# TECHNICAL BULLETIN

## Knocking Noise – Rear Subframe Bushing – Modification Procedure

**64-17**

MODEL 1988-94 MY Sedan

ILLUSTRATION 1

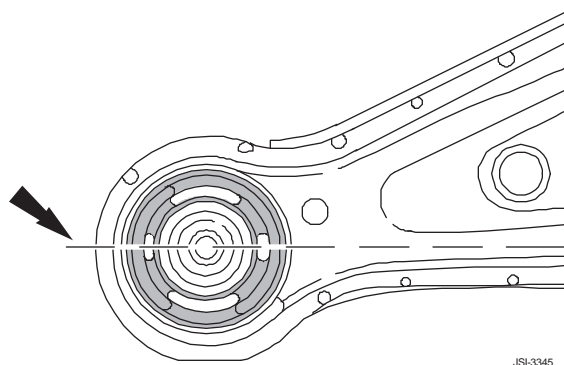
1. Remove the subframe from the vehicle.
2. Press out the old bushings from the subframe and thoroughly clean the bores and the surrounding areas.
3. Place the subframe on a bench and stretch a line or measuring tape through the centers of the two bores, as indicated in Illustration 1, to indicate the centerline.

- Place small squares of masking tape on the top face of each bore, under the line or tape. Mark the centerline, with pen or pencil, on the masking tape.

**Note:** When the bushing is installed the centerline should pass through the center of the two voids in the bushing, as shown in Illustration 1.

ILLUSTRATION 3

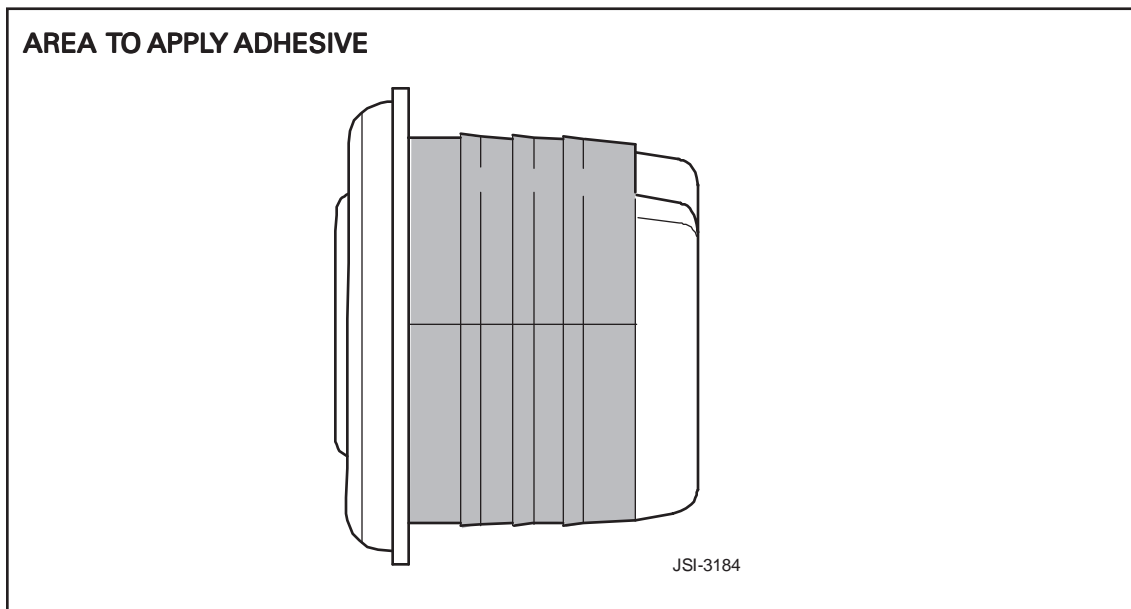
13. Apply the adhesive over the area of the bushing, shown shaded in Illustration 3, and the bore in the subframe.

ILLUSTRATION 4

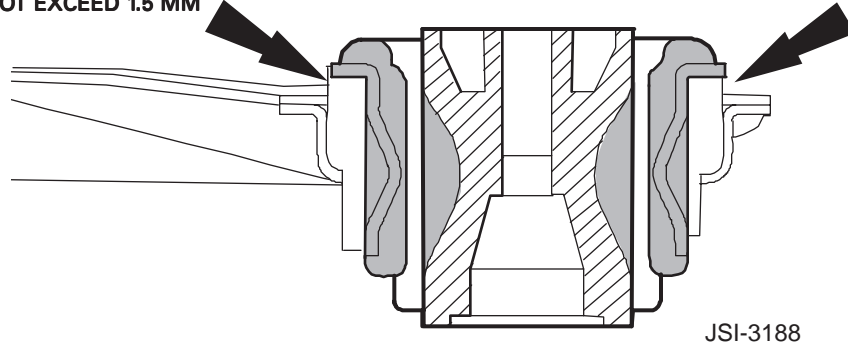
GAP MUST NOT EXCEED 1.5 MM

17. After the bushing has been inserted in the subframe, check for any clearance between the bushing flange and the subframe, (Illustration 4). If a gap is present, **it must not exceed 1.5 mm.**
18. Repeat the operation for the other bushing.
